PORSCHE-DIESEL

SERVICE BULLETIN #2

Subject: Miscellaneous Technical Information for Dealer and Customer

Clutch: The clutch pedal should be checked at least weekly for free play:

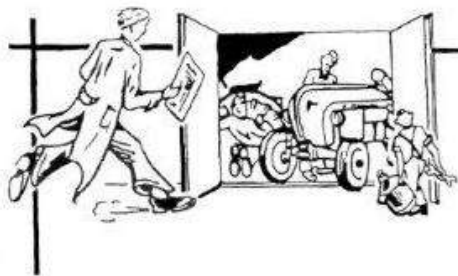
$\frac{1}{2}$ " on the foot plate

The adjusting screw is on the outside of the transmission housing close to the left foot plate. You will find a picture in the handbook "How I Service My PORSCHE-DIESEL", page 41, space 7.

SUPPLEMENT TO OUR SERVICE BULLETIN #23

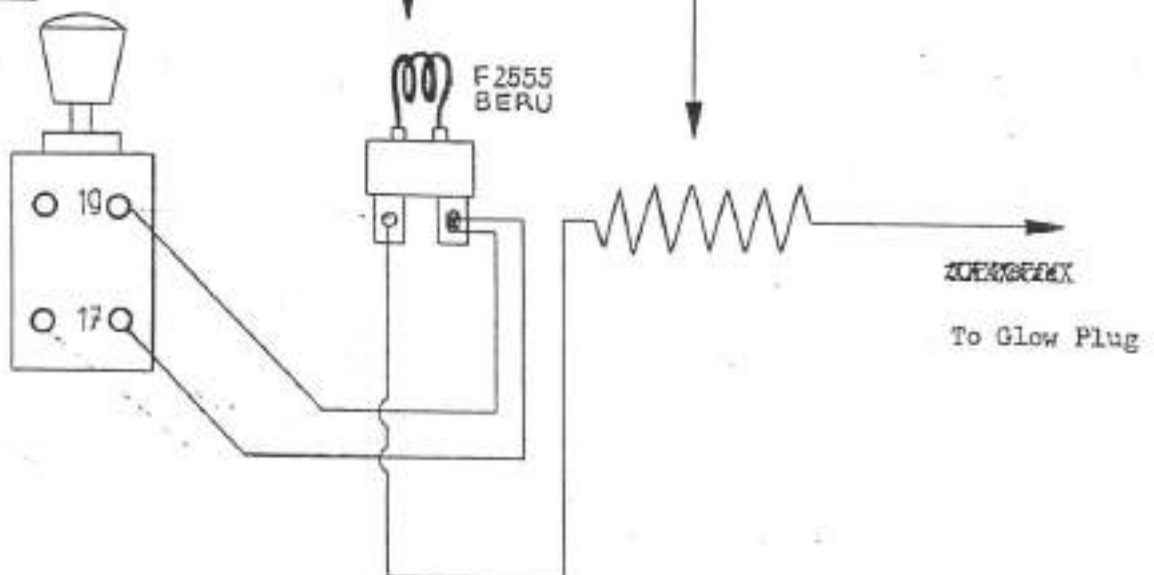
Various reports about failures of the glow plug MK 371 caused us to change the wiring system of the electrical starting equipment on tractors and engines stated below. This change reduces the current intensity which is delivered to the glow plugs during the starting procedure as - contrary to the former system - the glow wire of the glow control remains now within the circuit, at the same time, the glow control wire (In the dashboard) has to be placed by a new type of wire: BERU F2555 installation instructions page 3. Kindly check all tractors in your area and your own stock by the serial numbers listed on page 1 and let us know the required quantity of glow wires at once. To speed up the operation you may send your order directly to our service department or parts department in Easton, Pa. It would simplify the matter for us if you would refer in your order to this Service Bulletin.

From the attached wiring diagram you will see the former and the wiring system. We ask you to change the corresponding connections on the glow control according to the new wiring diagram on the following tractors:

In addition to our service circular mentioned above we went to provide some exact installing instructions for the medication of the electrical wiring system at the glow control.

Try which one of the black wires develops sparks when brought into contact with yellow -black wire (19). This wire (17) is to be connected to the glow control as single wire, the other one together with yellow-black wire.

Be careful that the wires are not mixed up, since, in this case the glow control will remain out of the circuit and the glow plug will be overstressed.
